Primary Engineering, Inc.
2828 Lake Ave.
Fort Wayne, Indiana 46805
260-424-0444 ph
www.primary-eng.com

Addendum: **1**
Date: **3/7/2025**
Project: **FWCS HPB Natatorium HVAC Improvements**

Comm #: **24634**

SHEET:
M401

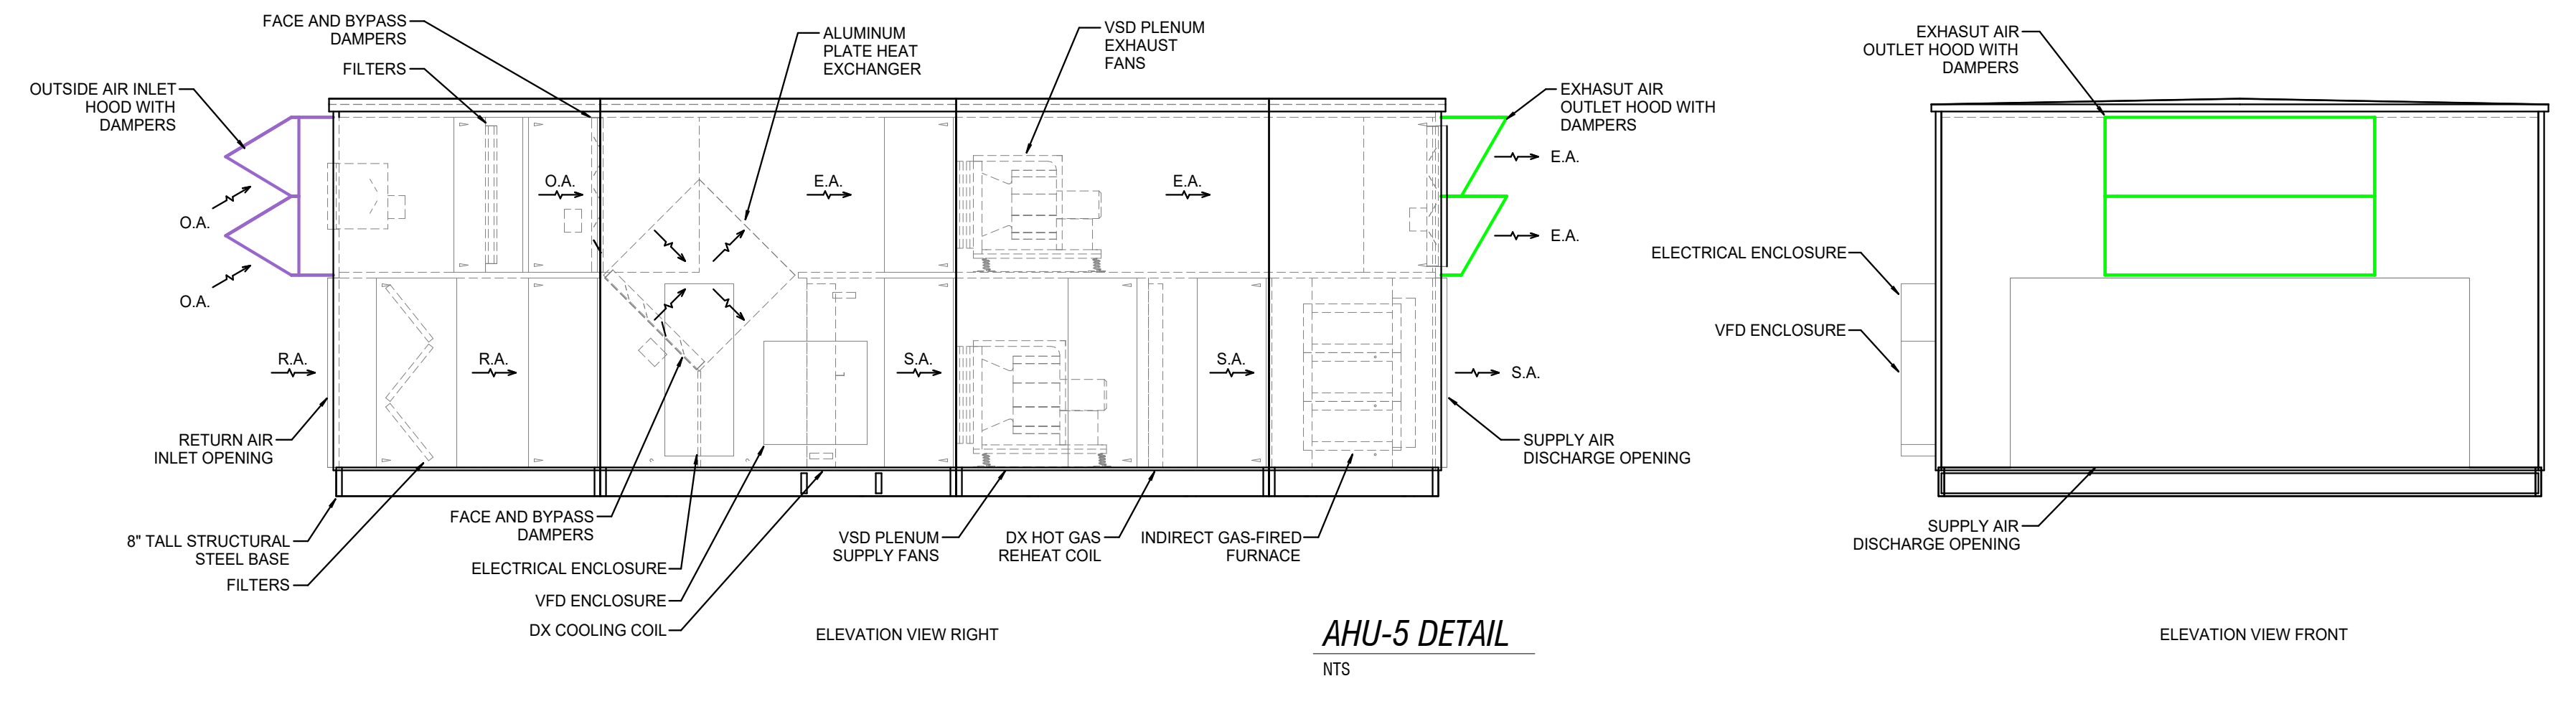
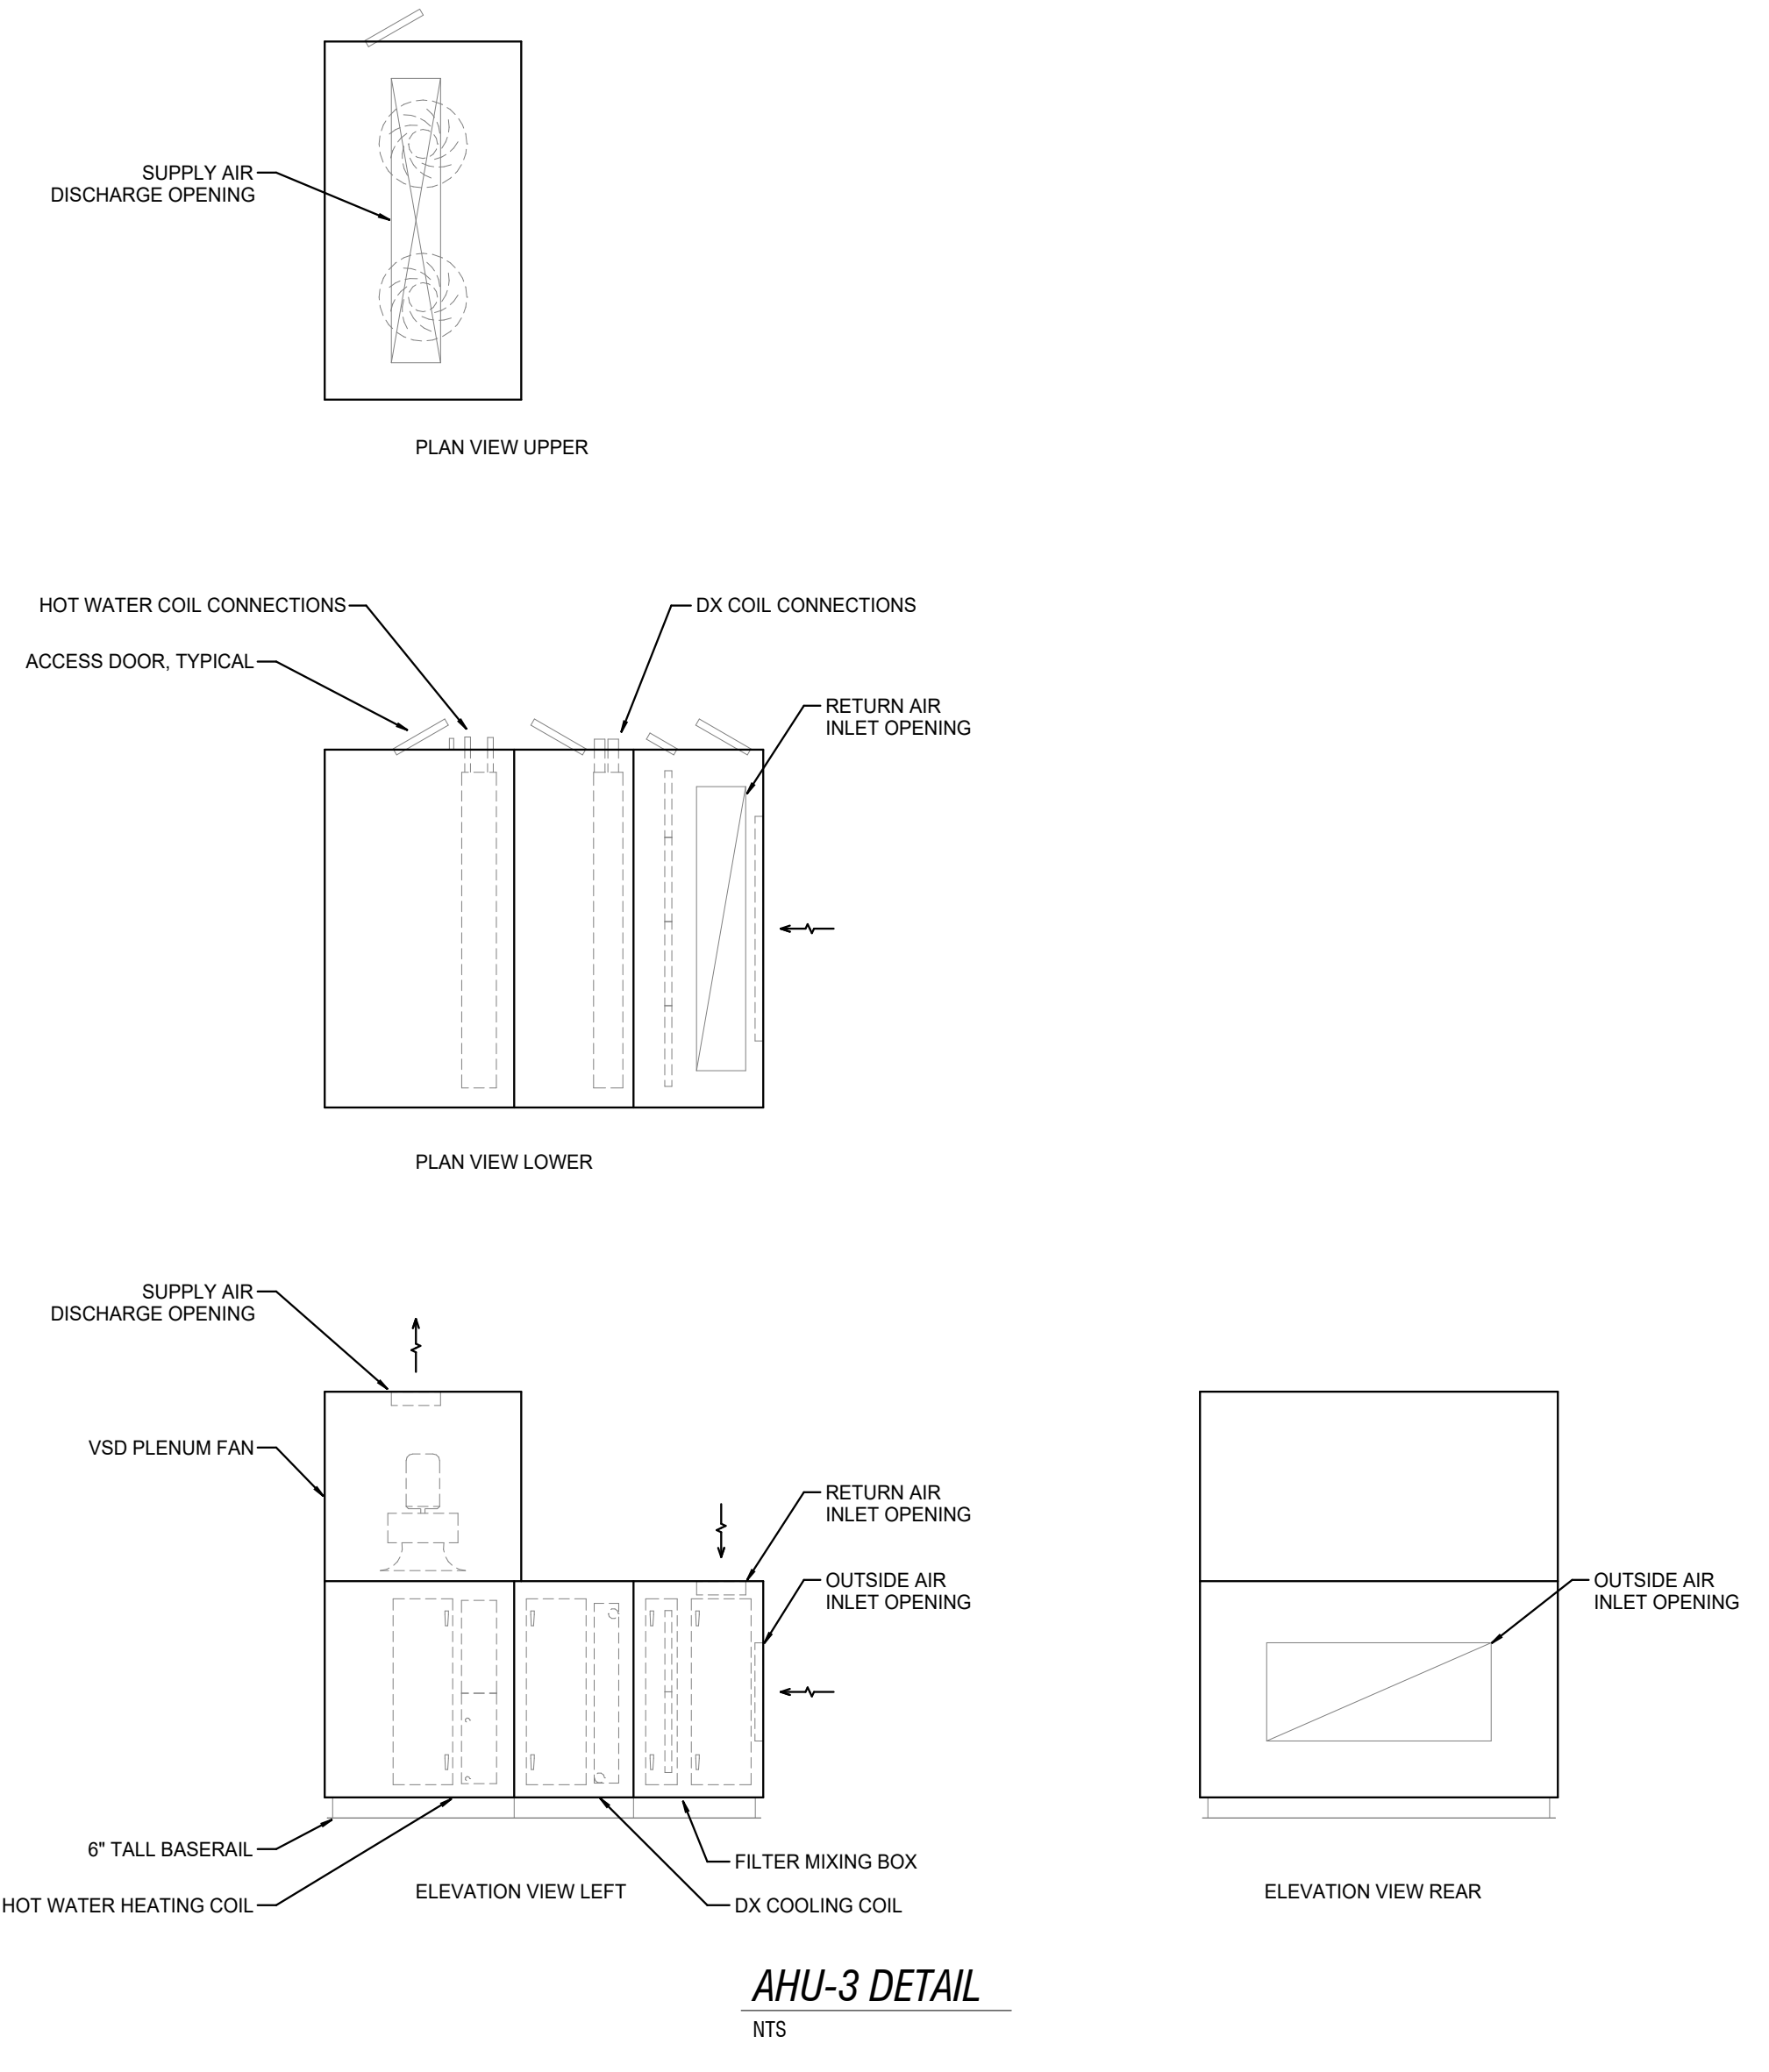
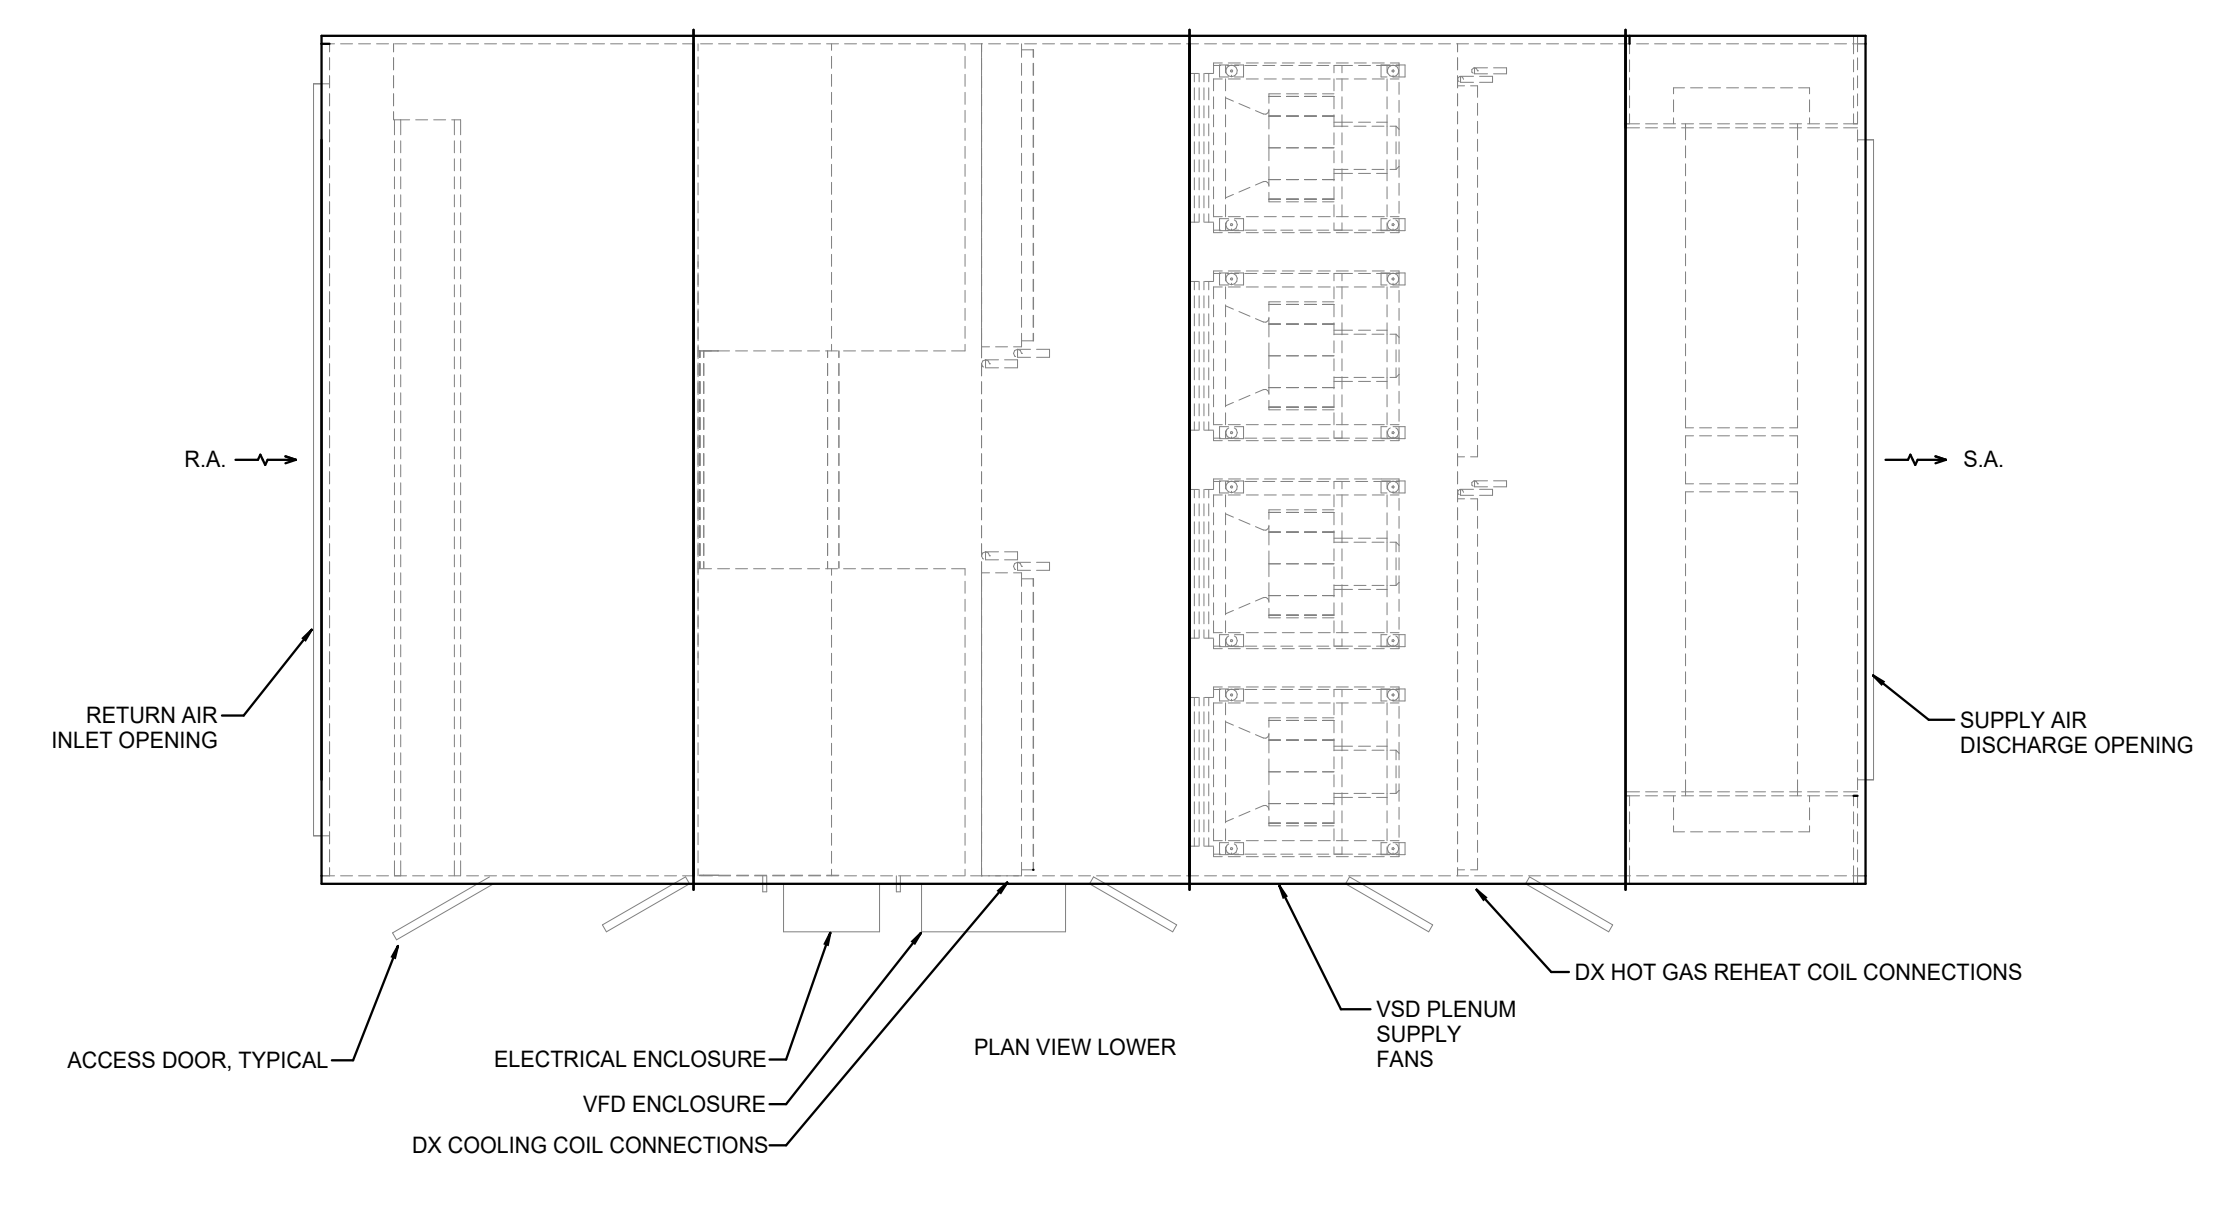
- A. Revise AHU-1 Detail. Revise AHU-2 Detail. See attached drawing revision to M401 dated 3/7/2025.
